**CITY OF TEMPE
DEVELOPMENT REVIEW COMMISSION**

**Meeting Date: 1/28/2014
Agenda Item: 4**

ACTION: Request for a Development Plan Review for eight new attached single-family townhomes for KENNETH PLACE TOWNHOMES, located at 1419 South Kenneth Place. The applicant is Neil Tang.

DPR13316 Development Plan Review including site plan, building elevations, and landscape plan

NORTH ELEVATION 4
1/8" = 1'-0"

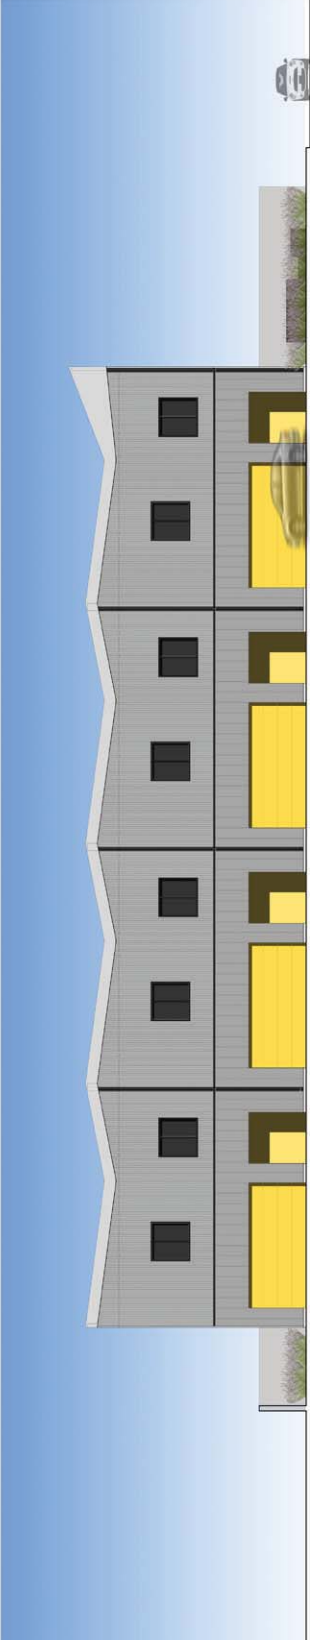
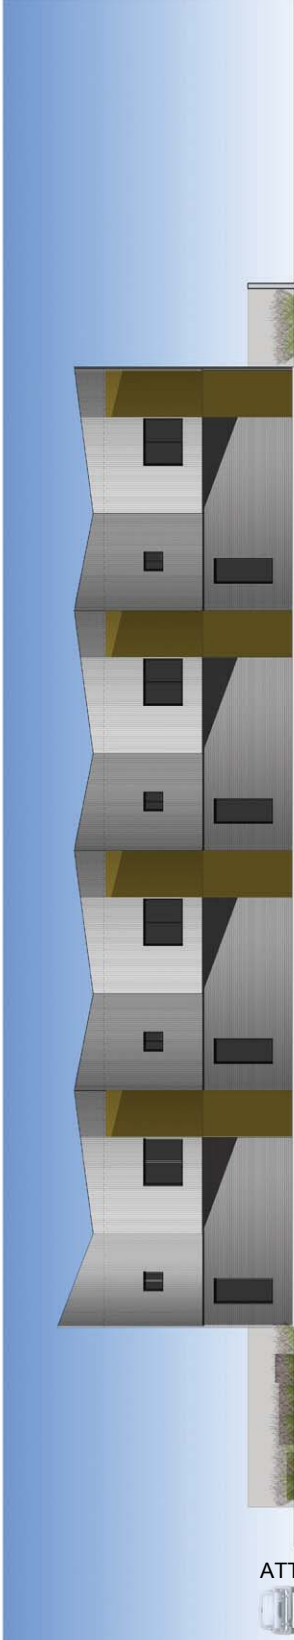
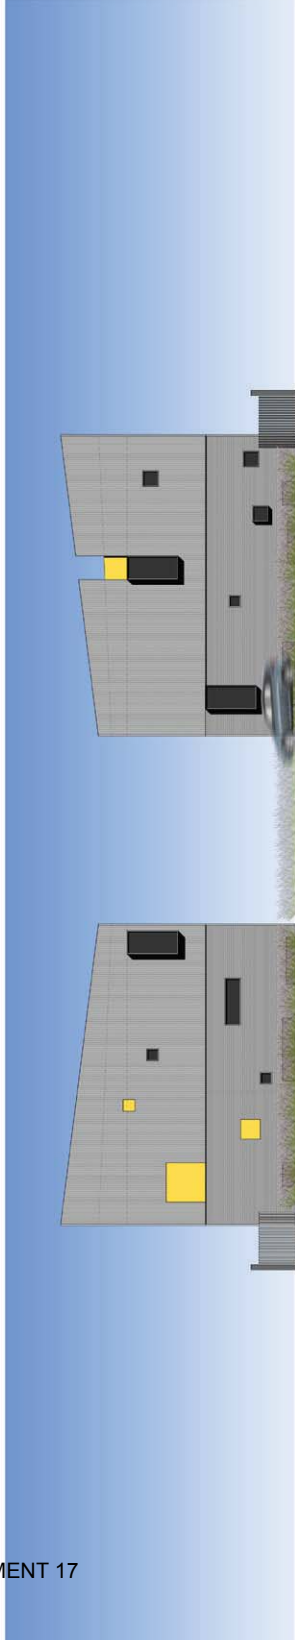
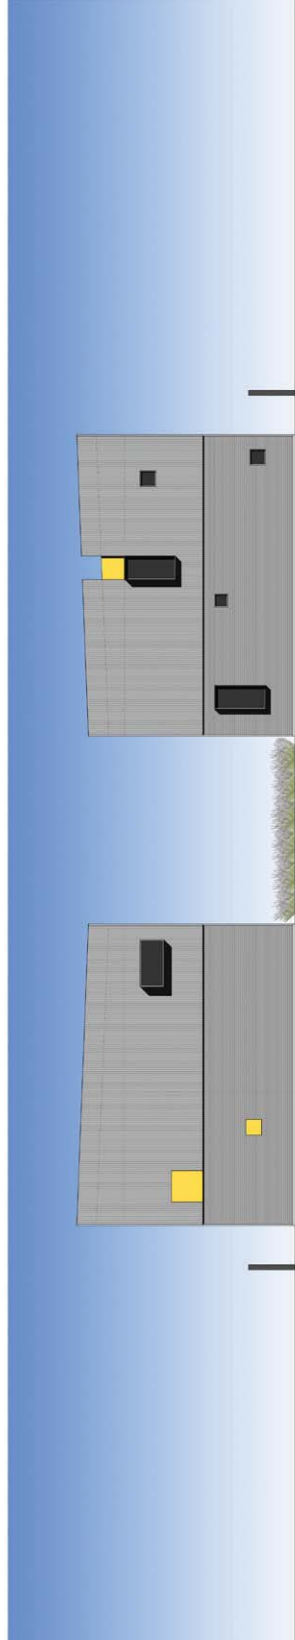
7. The materials and colors are approved as presented at the hearing:

Roof – flat with parapet

Main Body Color –Galvanized metal cladding: 2.67" x .875" corrugated metal siding installed both horizontally and vertically

Second Body Color – Galvanized 24 gauge flat panel flat lock clad system on lower level garage side of elevations

Accent courtyard stucco and garage doors – Benjamin Moore "Bumble Bee" (bright yellow)

2" diameter steel picket pedestrian fence and security gates –oxidized finish to be sealed

landscape plan
scale: 1/8" = 1'-0"

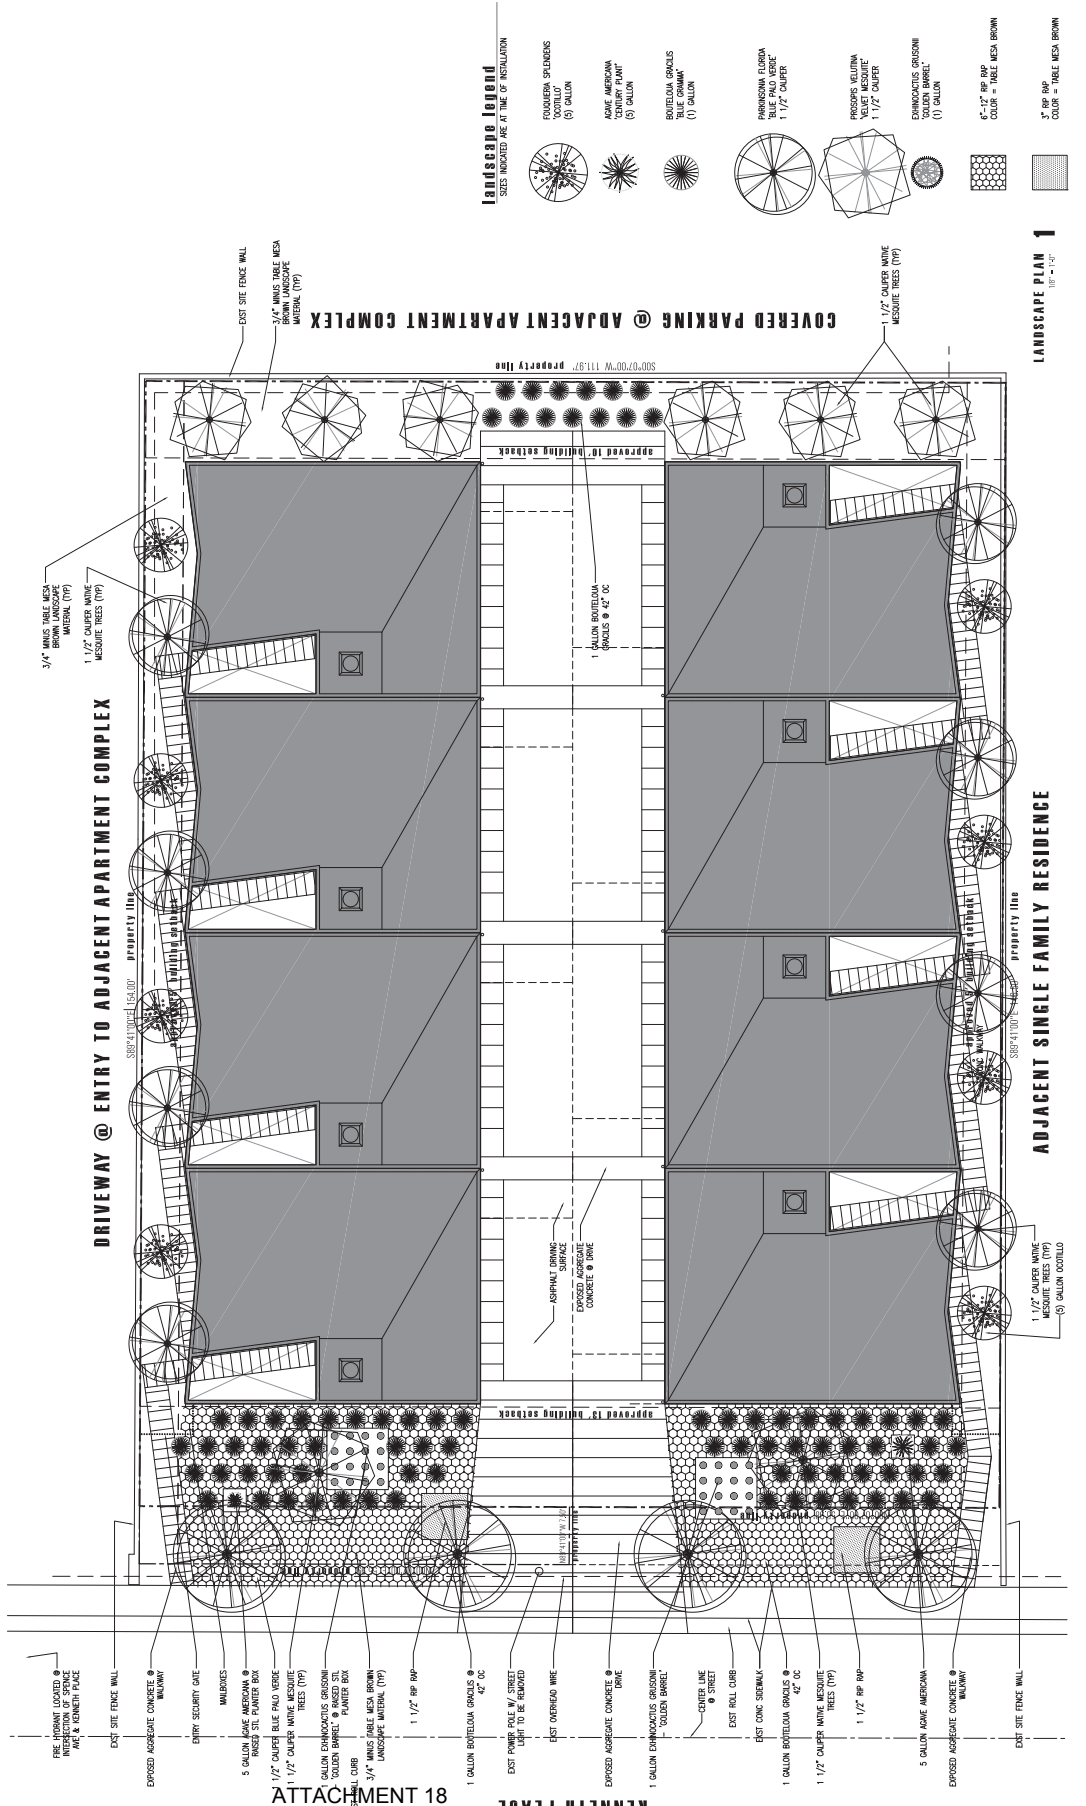
13. The plant palette is approved as proposed and specified on the landscape plan, with the following additions:
 - a. Trees along the north and east perimeter, in the location of the irrigation waterline shall be small patio trees with root barrier protection provided for the existing private waterline.
 - b. A variety of ground cover plantings are required along the north, east and south perimeter, for a total of 30% vegetative ground cover.
 - c. Any additions or modifications may be submitted for review during building plan check process.
